SAFETY RECALL – NORTH AMERICA

High Voltage Battery Fuse

Reference: 53A / NHTSA 23V-303

Remedy available for:
2022-2023 (JL) Jeep® Wrangler 4XE PHEV

Figure 8 – 200A Fuse Fasteners

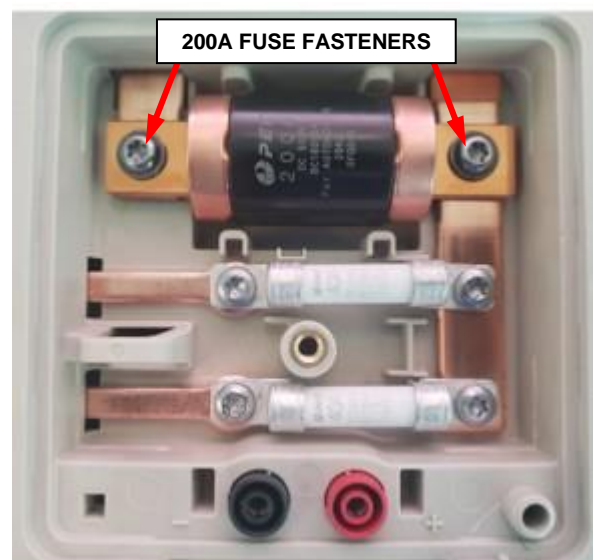
2. Inspect the 200A fuse fasteners in the fuse tray under the fuse cover (Figure 8).

Figure 9 – 200A Fuse Fastener Inspection

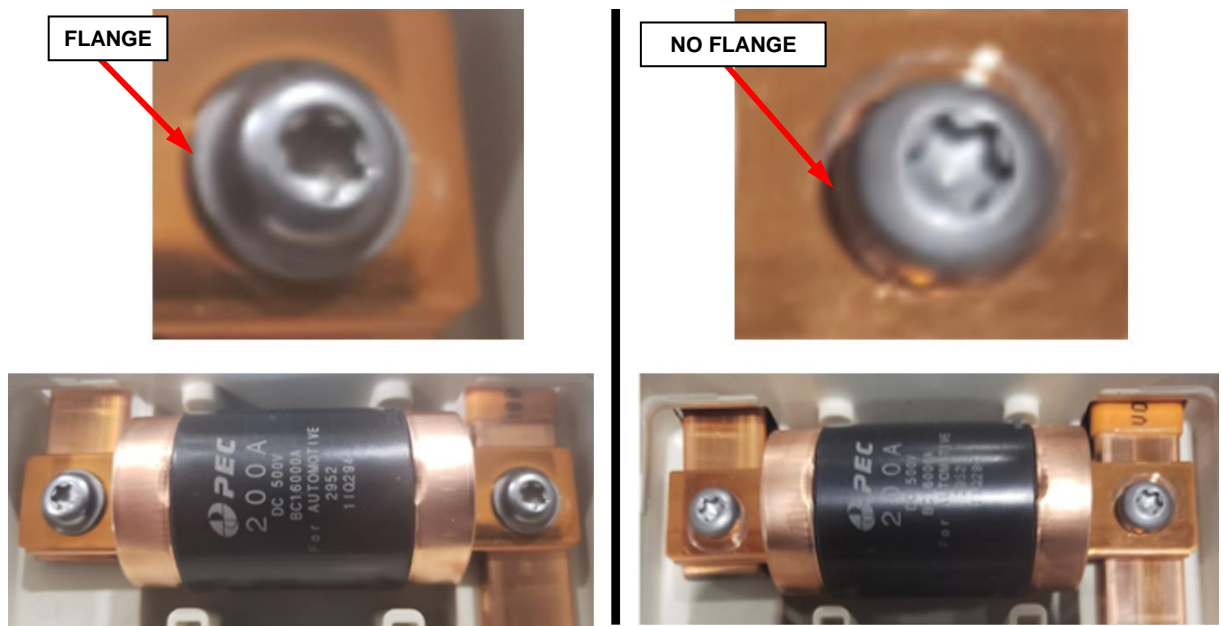
3. Do the 200A fuse fasteners have a flange around the screw head or not as shown in (Figure 9)?
- **Correct Screws - Flange Head:** No further action required. Vehicle may be reassembled. Proceed to **Step 10**.
 - **Incorrect Screws – No Flange:** Continue with **Step 4**.

Correct Screws - Flange Head

Incorrect Screws – No Flange

4. Remove the incorrect fasteners securing the 200A fuse then also remove the fuse (Figure 9).

Figure 10 – Inspect for Signs of Carbon Marking

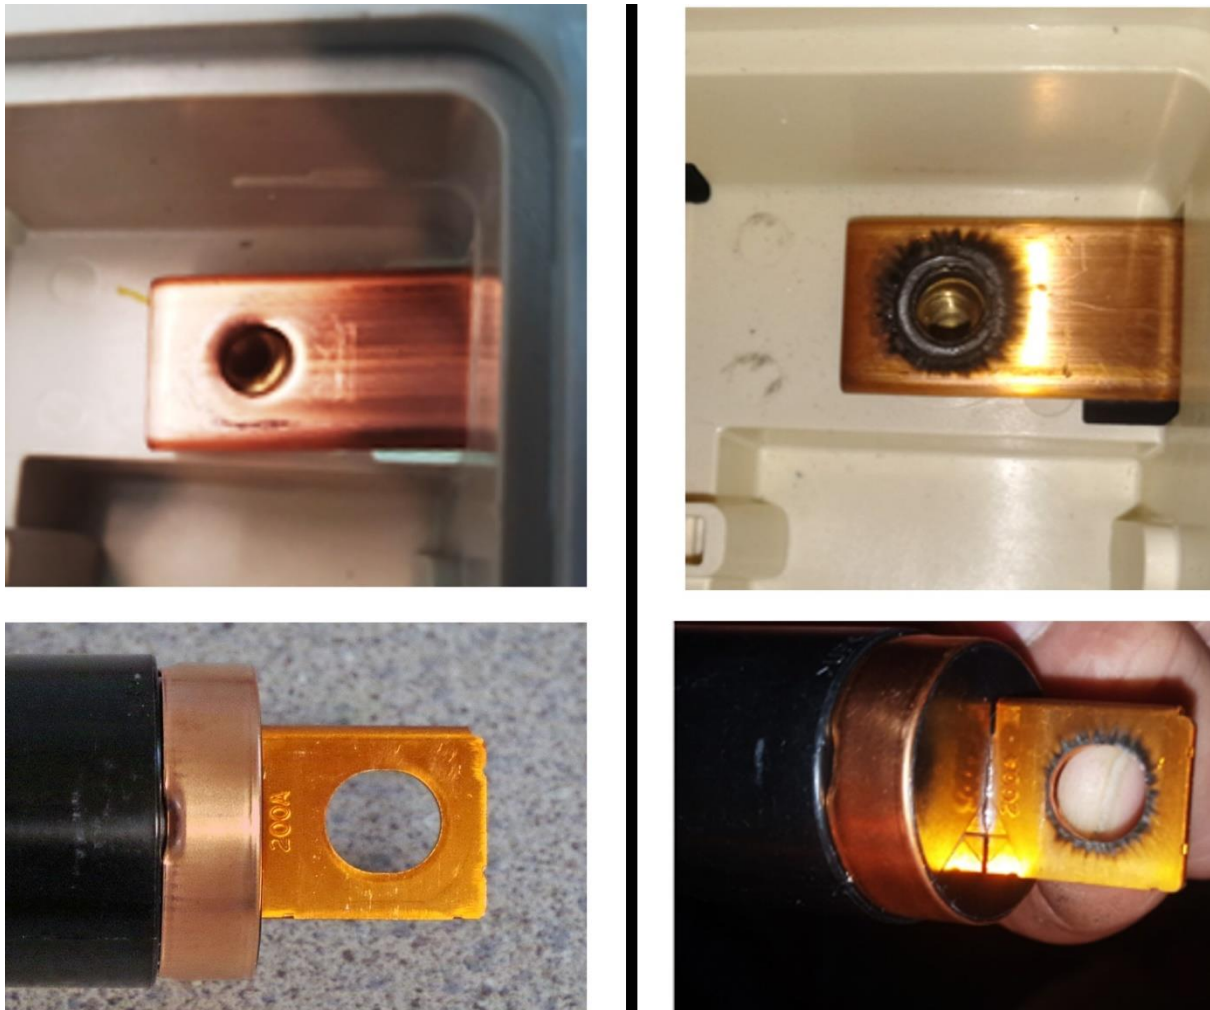
5. Inspect the 200A fuse and bus bar contacts for any signs of carbon marking as shown in (Figure 10).

Good Contacts No Carbon Marking

Signs of Carbon Marking

7. Were the bus bar contacts clean or carbon marked as shown in (Figure 10)?
 - **Clean, no Carbon Marks:** Replace the 200A fuse and fasteners. Continue with **Step 8**.
 - **Visible Carbon Marks:** Battery will require replacement Proceed to **Section C**.
8. Order and obtain the 200A fuse kit with proper screws. The photographs taken previously will be required to place the parts order.
9. Replace the 200A fuse and fasteners from the kit then tighten the screws to 5.7 N·m (50 in. lbs.) (Figure 8)
10. Install the fuse cover then tighten the cover screw to 6 N·m (53 in. lbs.) (Figure 7).
11. Power up the HV battery system.
